Access Compliance Report

Public Rights-of-Way

(Curb Ramps)

Intersection ID: N/A	Main Street: INDEPENDENCE_BV	Cross Street: BUICK_DR	Location: SW
ADA ID: 21E4356B6419	Ramp Type: Perp	Initial Pass/Fail: Fail	Overall Compliance: No
		Severity Score: 12.5

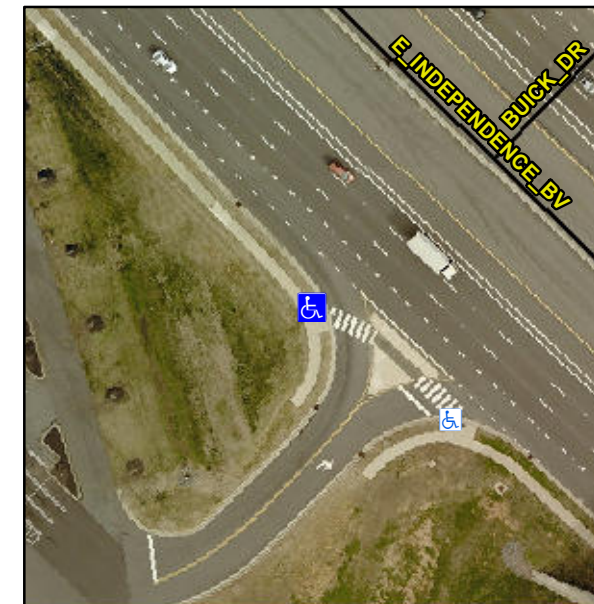
R304.2.2

Compliance	Description	Data	Compliance	Description	Data
N/A	Ramp Length (in)	65.0	No	Ramp Slope (%)	8.5
Yes	Ramp Width (in)	59.0	Yes	Ramp XSlope (%)	1.7
N/A	Flare Type LT	N/A	N/A	Flare Type RT	N/A
N/A	Flare Slope LT (%)	N/A	N/A	Flare Slope RT (%)	N/A
N/A	Flare Traversable LT?	N/A	N/A	Flare Traversable RT?	N/A
N/A	Landing Length (in)	N/A	N/A	DWS Provided?	N/A
N/A	Landing Width (in)	N/A	N/A	DWS Contrast?	N/A
N/A	Landing Slope (%)	N/A	N/A	DWS Length (in)	N/A
N/A	Landing X Slope (%)	N/A	N/A	DWS Full Width?	N/A
N/A	Landing Curb? (Y/N)	N/A	N/A	DWS Offset (in)	N/A
N/A	Shared Landing?	N/A			
N/A	Gutter Ponding?	N/A	N/A	Gutter Slope (%)	N/A
N/A	Gutter Lip Ht (in)	N/A	N/A	Gutter X Slope (%)	N/A
N/A	Painted X Walk1?	Yes	N/A	Painted X Walk2?	N/A
	X Walk 1 Direction	To SE		X Walk 2 Direction	N/A
N/A	X Walk 1 Width (in)	116.0	N/A	X Walk 2 Width (in)	N/A
	X Walk 1 Slope (%)	0.6		X Walk 2 Slope (%)	N/A
	X Walk 1 X Slope (%)	0.2		X Walk 2 X Slope (%)	N/A

Remove & Replace Entire Ramp.
